STATE OF NORTH CAROLINA
DEPARTMENT OF TRANSPORTATION

Addendum No. 1
RE: Contract # C204039
WBS # 34243.3.2
STATE FUNDED
Polk County (I-4729A)
I-26/US-74/NC-108 Interchange Modifications in the Town Of Columbus

September 19, 2017 Letting

The following revisions have been made to the Roadway plans:

0 5 10
PROJ. REFERENCE NO.
I-4729A
SHEET NO.
X-37
6/23/16
1080
1070
1060
1050
1040
1030
0.008
0.008
SP-20
1029.54
18+50.00
0.006
0.006
SP-22
1028.57
18+00.00
-RP_F-
14-AUG-2017 08:19
J:\I-4729A\Roadway\XSC\I-4729A_Rdy_xpl.dgn
$$$$USERNAME$$$$

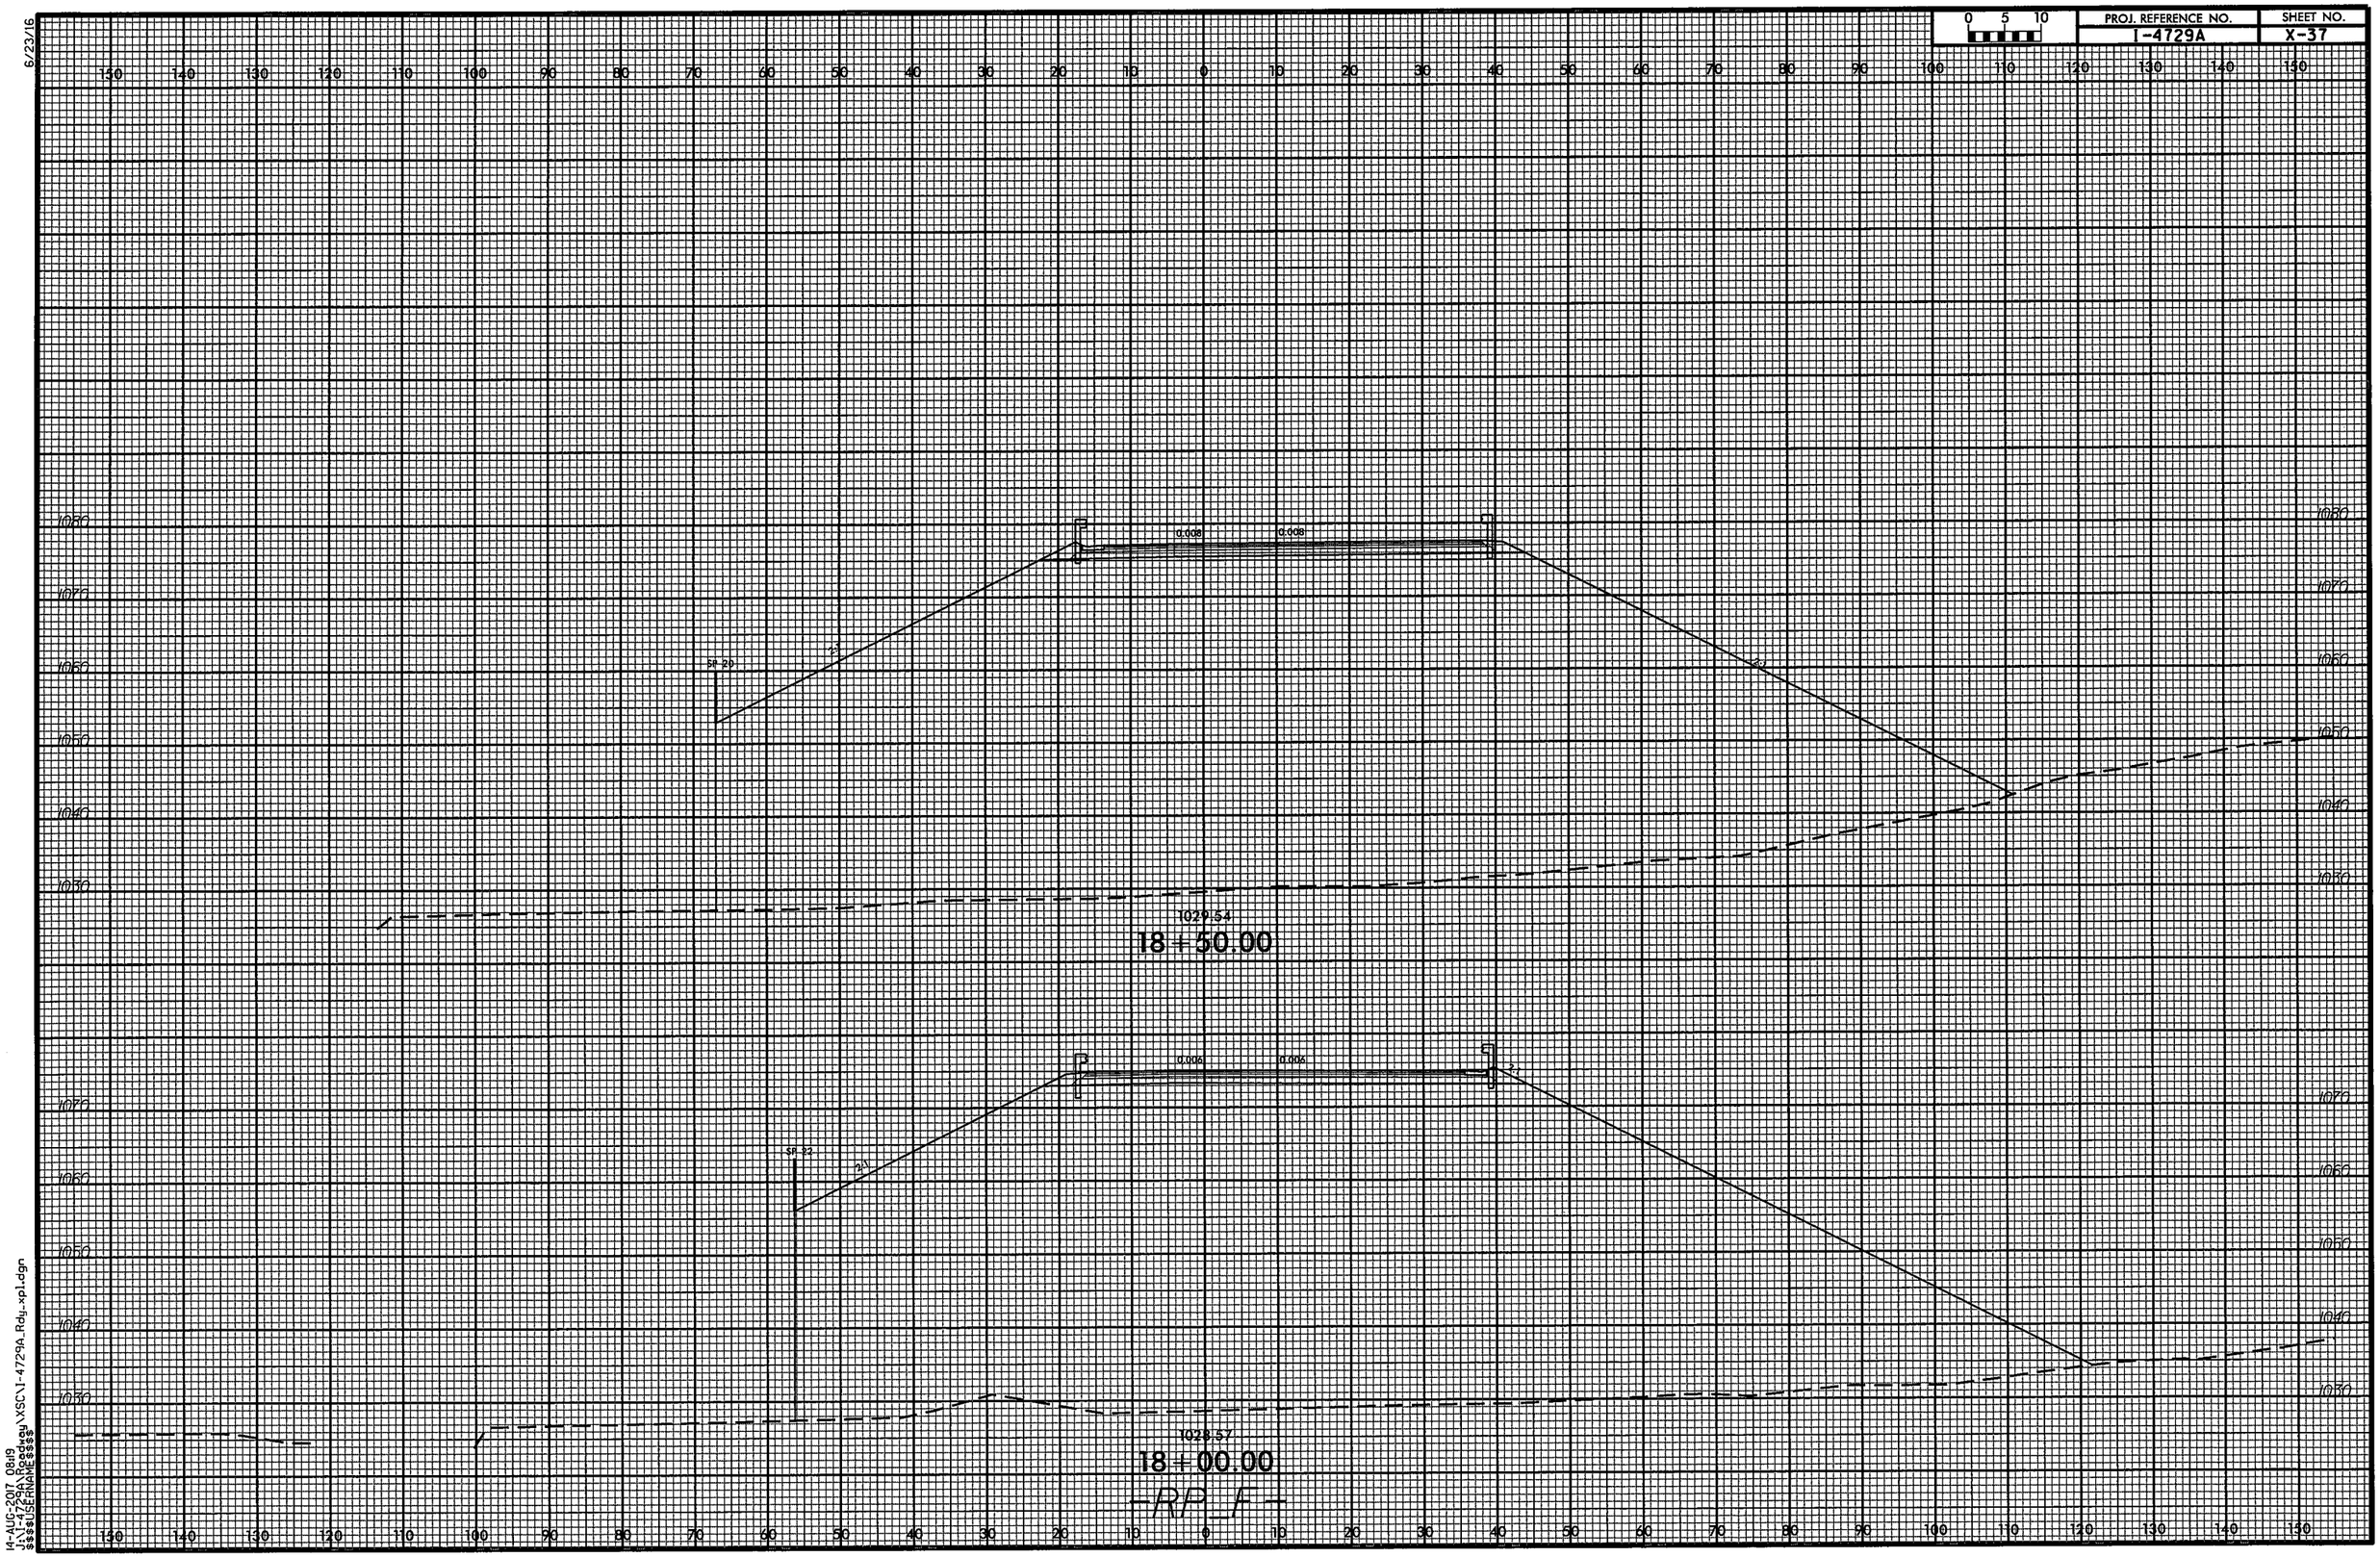
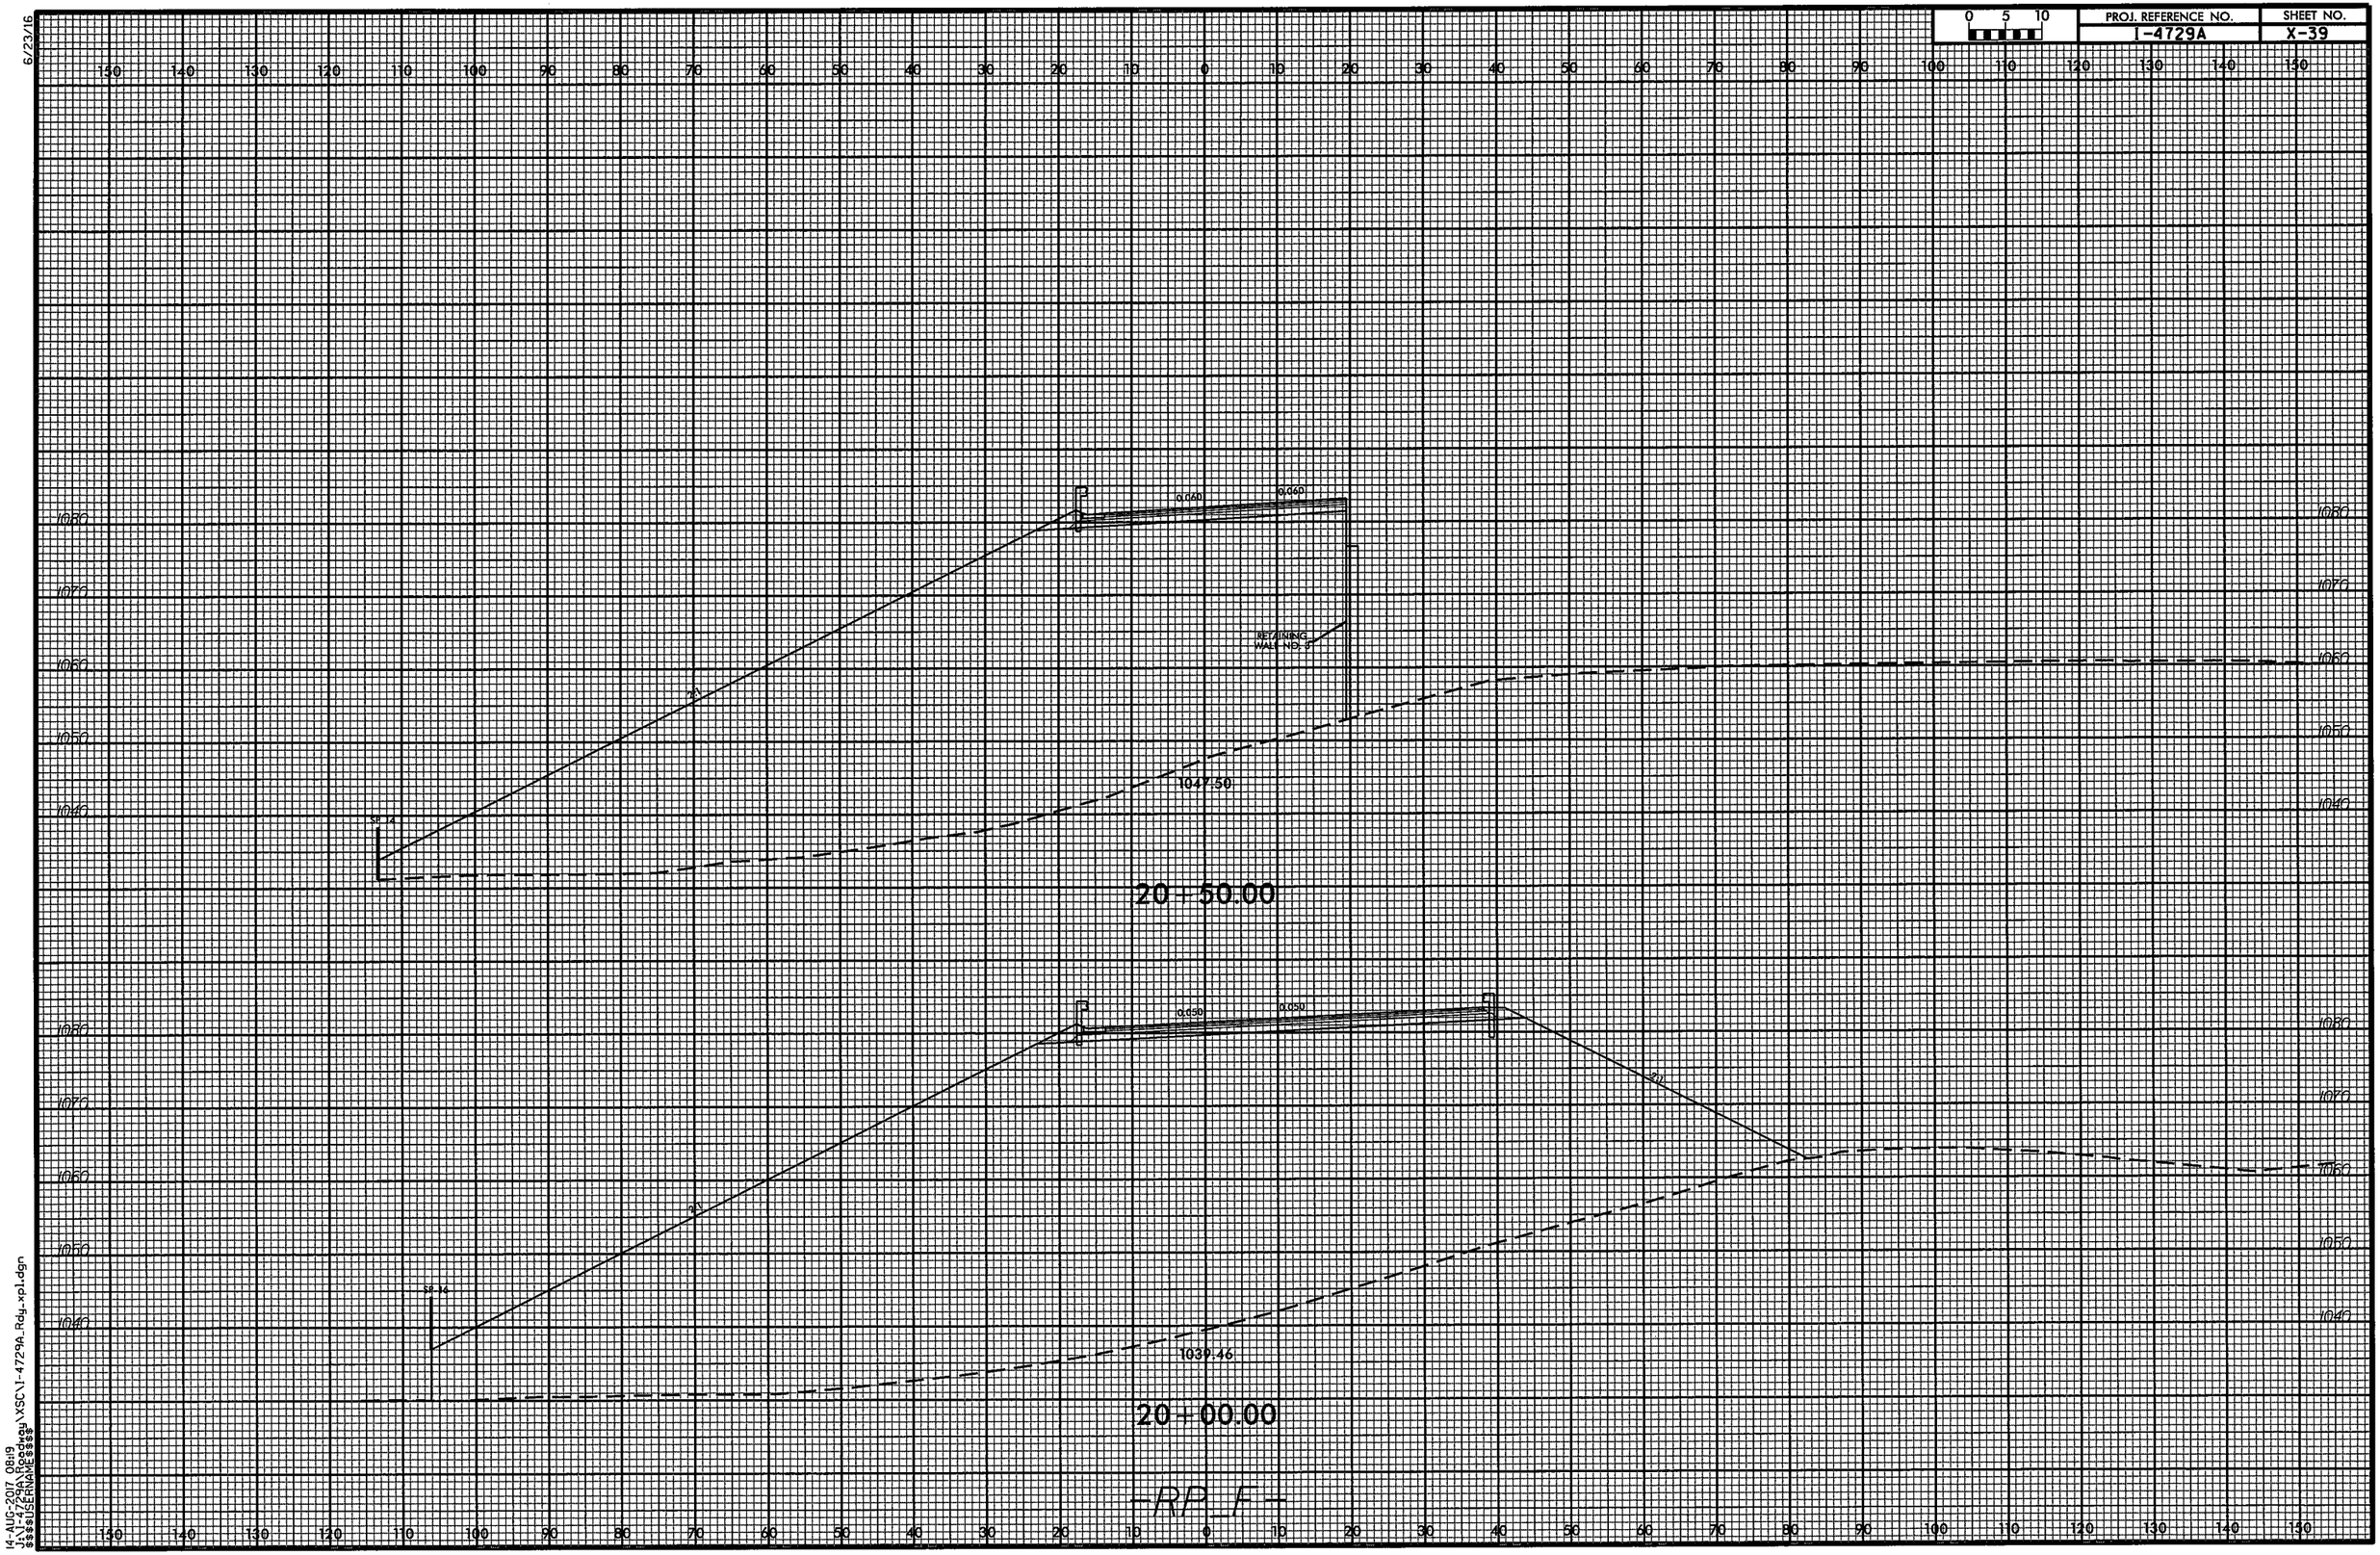
Sheet No.	Revisions
1A	Revised Index of Sheets to remove 2G-2 "Standard Embankment Monitoring Detail" and revise the number of" Drainage Summaries" sheets
2A-1, 2A-4 and 2A-5	Revised the Typical Sections for the change in mainline pavement widening design from ABC to Asphalt Base
3B-1	Revised 'Summary of Earthwork' to account for pavement widening design change
3D-1 thru 3D-4	Various drainage quantity changes as noted below
3G-1	Removed "Settlement Gauge Summary" and added note that Bridge Waiting Period only applies to Approach Slab construction
5	Revised to require Welded Steel Pipe by Trenchless method under the Interstate 26
X-1A thru X-87	Revised Cross-Sections to reflect the change in Earthwork due to the pavement design change
